Invitation to Bid 16068 Fabricated Steel Module Structure
Addendum 1

Addendum 1 is issued to answer the following questions:

**STATE OF ALASKA, AIDEA/AEA
RURAL POWER SYSTEM UPGRADE**

KIPNUK LIGHT PLANT
KIPNUK, ALASKA

3
A4 CONTROL ROOM WALL INTERIOR ELEVATION
3/8"=1'-0"

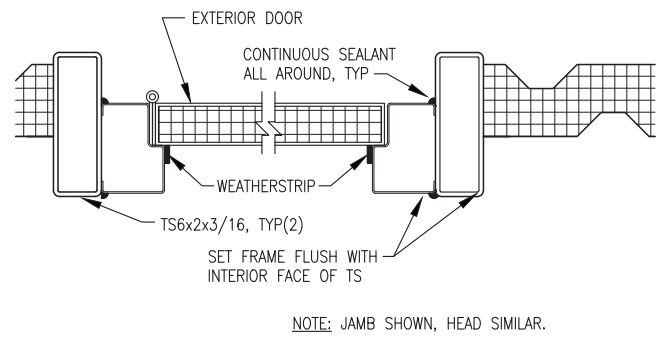
11. On Sheet A4, details 1 & 2 denote the interior elevations as being 11'6". Detail 3 shows the control room interior as being 10' in height. The measurement given does seem to indicate that the control room measurement is to the bottom of the 6"x4" header. Even so, assuming that the header accounts for 6", there is a 1' disparity. Is this an accurate measurement?

Answer: The control room height is 11'-6" to the bottom of the 6x4 header. See sheet A4 Revision 1 for a corrected detail.

6
A4 INTERIOR DOOR AND WINDOW JAMB/HEAD
3"=1'-0"

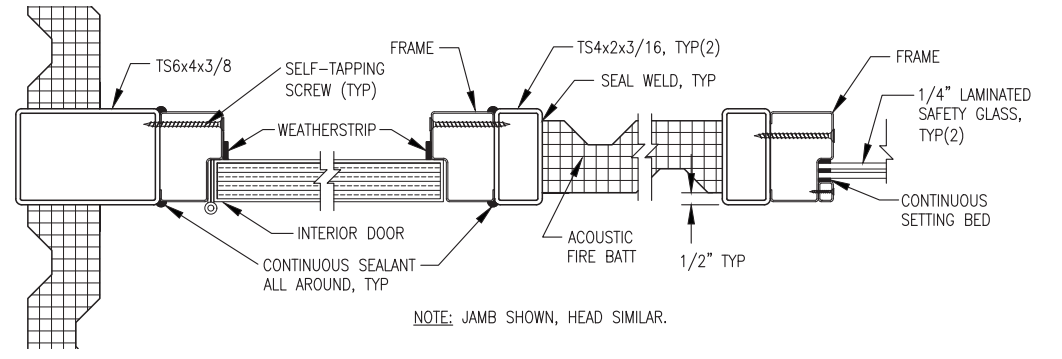
1. Sheet A4, det. 6 (lower right hand corner of page) calls out the exterior wall column as TS 6 x 4 x 3/8, and on Sheet A2 calls it out as TS 6 x 4 x 1/4 in det. 1, which is correct?

3. In reference to door jambs, sheet A4, det. 6, calls out as TS 4 x 2 x 3/16 and det. 3, same sheet A4 calls out TS 6 x 2 x 3/16?

Answer: The structural column at Grid 3 is a TS 6 x 4 x 3/8 as indicated on sheet S4 while the non-structural column at Grid 2 may be a TS 6 x 4 x 1/4 as indicated on sheet A2.

Answer: The door jambs on the interior walls (Grids 2 and 3) are TS 4 x 2 x 3/16 while the door jambs on the exterior wall (Grid A) are TS 6 x 2 x 3/16.

DRAWING TITLE:
MODULE CONNECTION
DETAILS

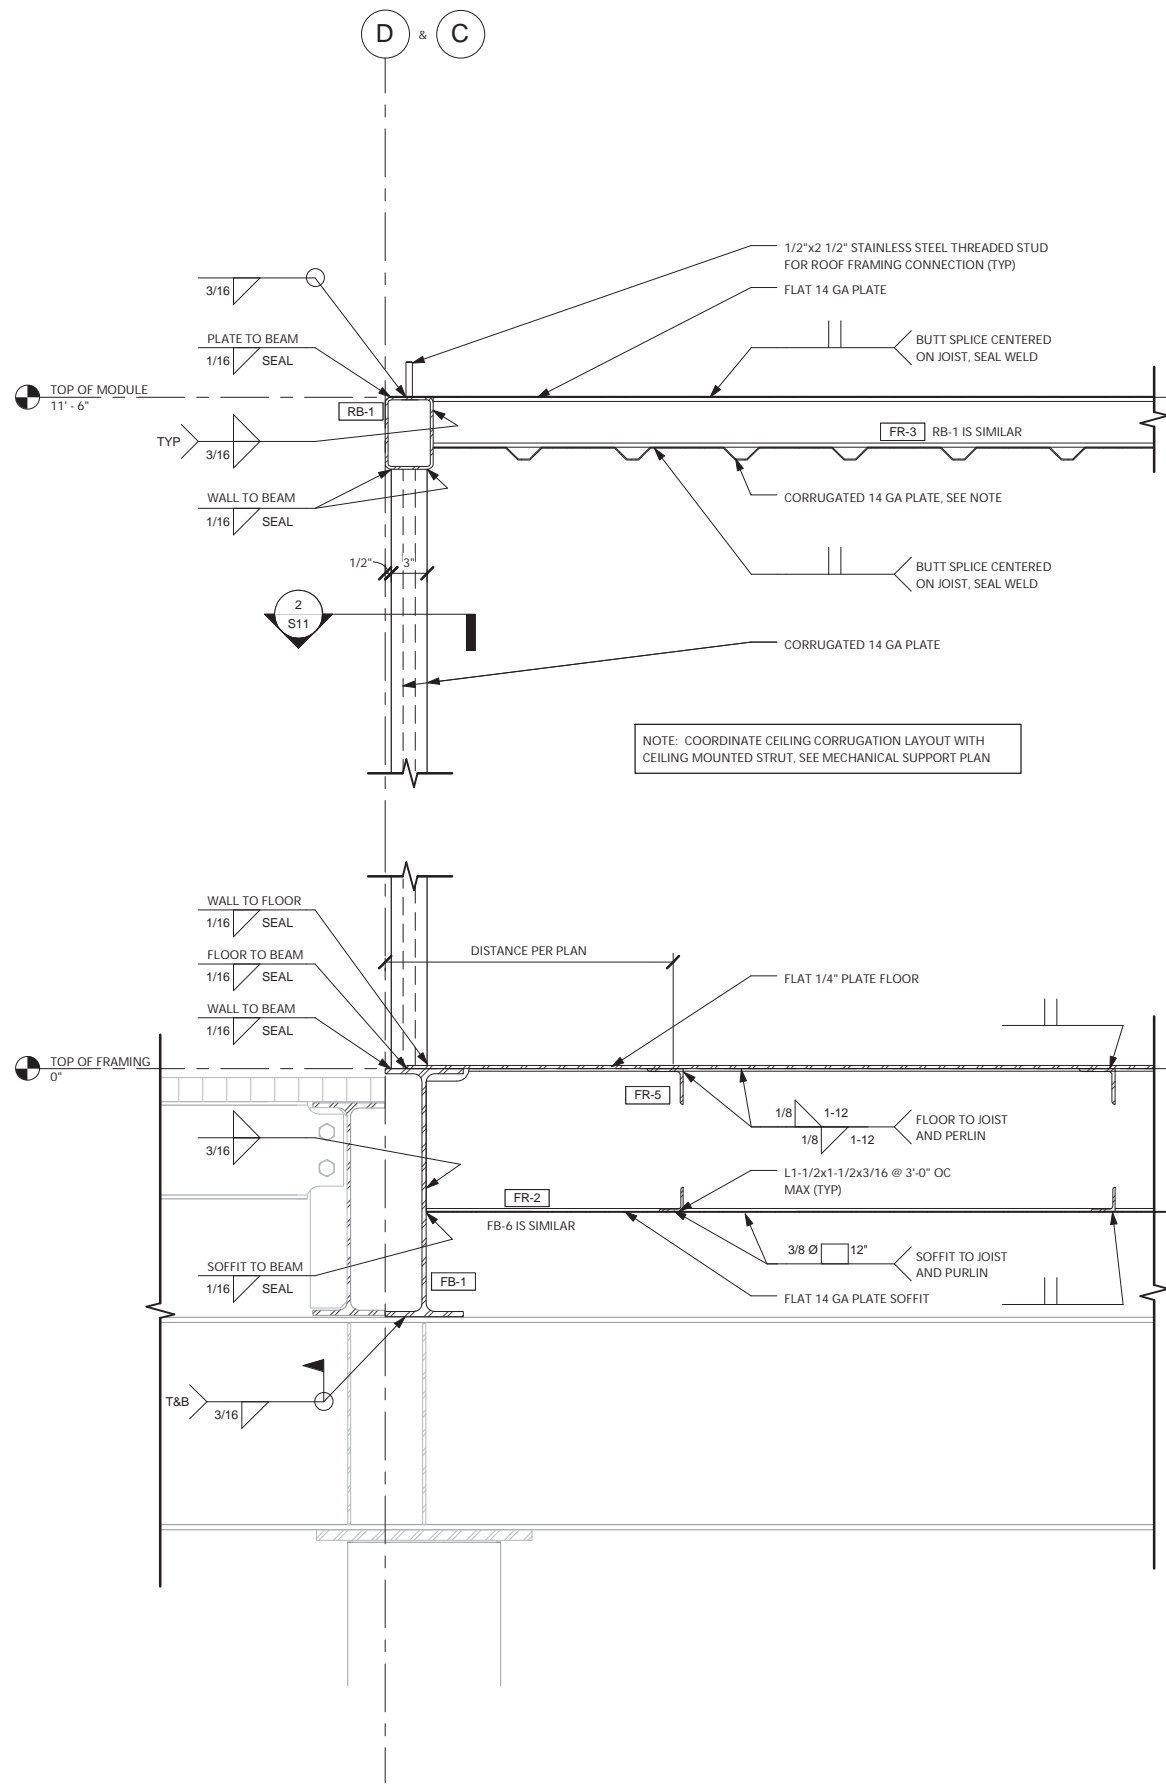
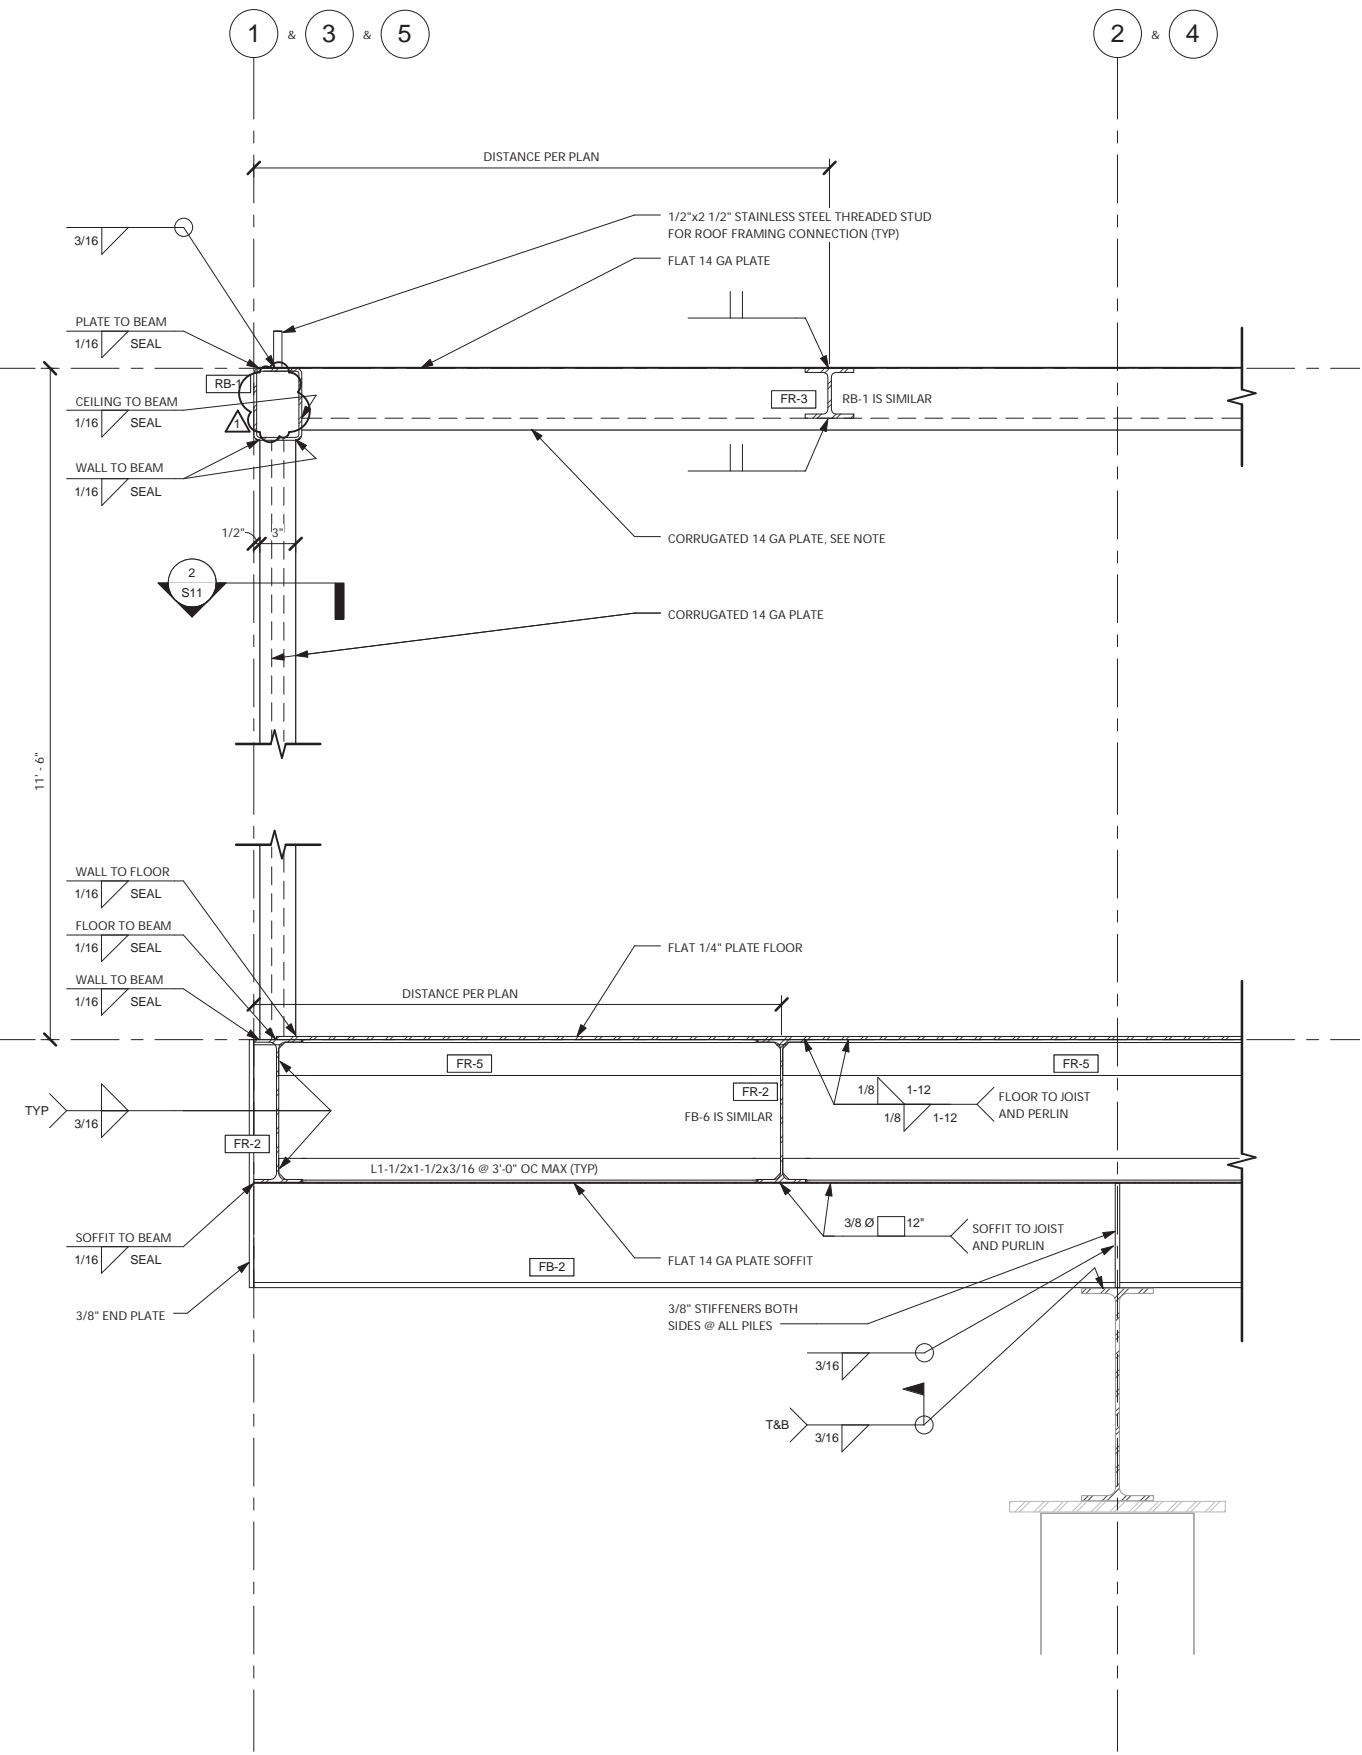
8. Sheet 5, grids 1,3, and 5 show some sort of stud into the tube?

Answer: There is no stud in the tube. See sheet S5 Revision 1 for a corrected detail.

1 LIFTING EYE & COLUMN CONNECTION
S11 1 1/2" = 1'-0"

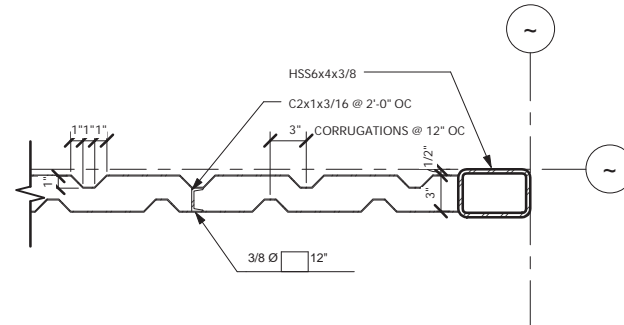
9. It appears the 4-each lifting eyes at the common end walls will conflict with each other as drawn. Can they be rotated 90 degrees? This would position them knifed into the tube column the 6" way, thus leaving a 1/4" of the 6 1/2" pad eye exposed for welding. The way depicted at present, knifed in the 4" way leaves a 1 1/4" exposed each side of the tube column thus they would butt up against each other leaving a 2 1/2" gap between the modules.

Answer: The detail has been corrected to show the 6-1/2" pad eye running parallel to Grid lines 1, 3, and 5 (the 6" dimension of the tube). See sheet S11 Revision 1 for a corrected detail.
